# Access Compliance Report

## Public Rights-of-Way

### (Curb Ramps)

Intersection ID: 13806	Main Street: S_TRYON_ST	Cross Street: WEST_BV	Location: S
ADA ID: E9E3288FB537	Ramp Type: Perp	Initial Pass/Fail: Fail	Overall Compliance: No
		Severity Score: 8.75

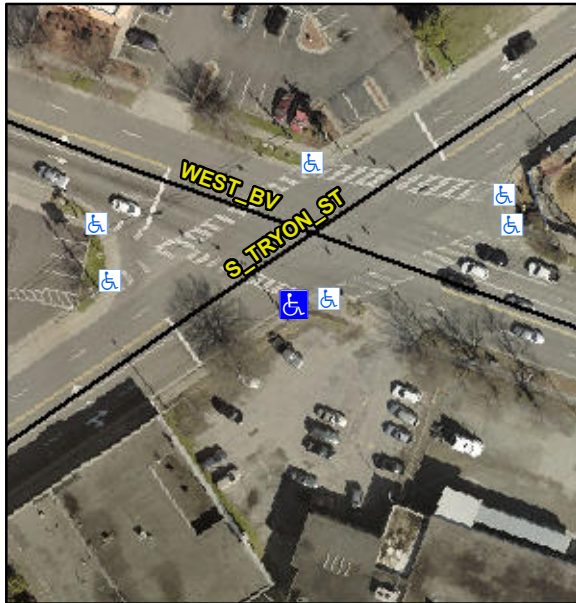
**Not Found, R304.5.1**

Compliance	Description	Data	Compliance	Description	Data
N/A	Ramp Length (in)	57.0	Yes	Ramp Slope (%)	6.7
No	Ramp Width (in)	36.0	Yes	Ramp XSlope (%)	1.8
N/A	Flare Type LT	N/A	N/A	Flare Type RT	N/A
N/A	Flare Slope LT (%)	N/A	N/A	Flare Slope RT (%)	N/A
N/A	Flare Traversable LT?	N/A	N/A	Flare Traversable RT?	N/A
N/A	Landing Length (in)	N/A	N/A	DWS Provided?	N/A
N/A	Landing Width (in)	N/A	N/A	DWS Contrast?	N/A
N/A	Landing Slope (%)	N/A	N/A	DWS Length (in)	N/A
N/A	Landing X Slope (%)	N/A	N/A	DWS Full Width?	N/A
N/A	Landing Curb? (Y/N)	N/A	N/A	DWS Offset (in)	N/A
N/A	Shared Landing?	N/A			
N/A	Gutter Ponding?	N/A	N/A	Gutter Slope (%)	N/A
N/A	Gutter Lip Ht (in)	N/A	N/A	Gutter X Slope (%)	N/A
N/A	Painted X Walk1?	Yes	N/A	Painted X Walk2?	N/A
	X Walk 1 Direction	To NW		X Walk 2 Direction	N/A
N/A	X Walk 1 Width (in)	58.0	N/A	X Walk 2 Width (in)	N/A
	X Walk 1 Slope (%)	3.3		X Walk 2 Slope (%)	N/A
	X Walk 1 X Slope (%)	2.5		X Walk 2 X Slope (%)	N/A

**Remove & Replace Entire Ramp.**
